# Shared Path Safety Cranford St

# Dangerous Design Waitomo Cranford

## Car parks on the road removed

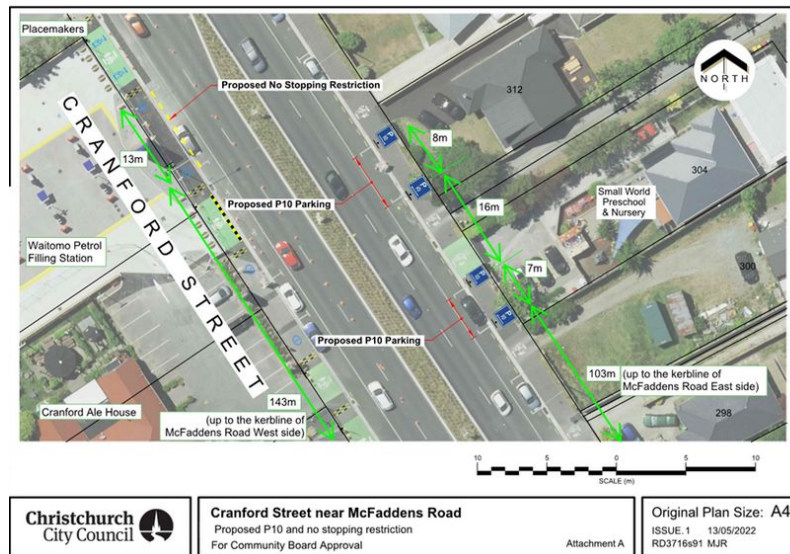
This has made it more dangerous, as now cars stop on the shared path rather than driving onto the road to see oncoming cars.

## Cranford Street cycle safety improvements - west side

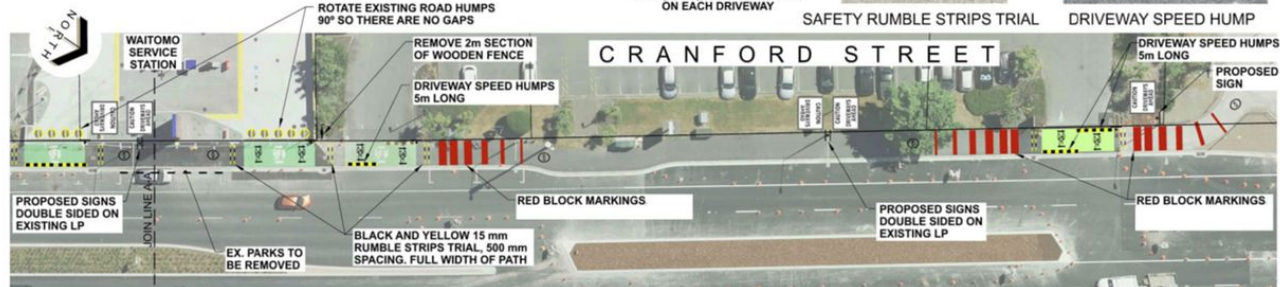
Rumble strips were added

Slow down signs

2 metres of wooden fence  
was removed
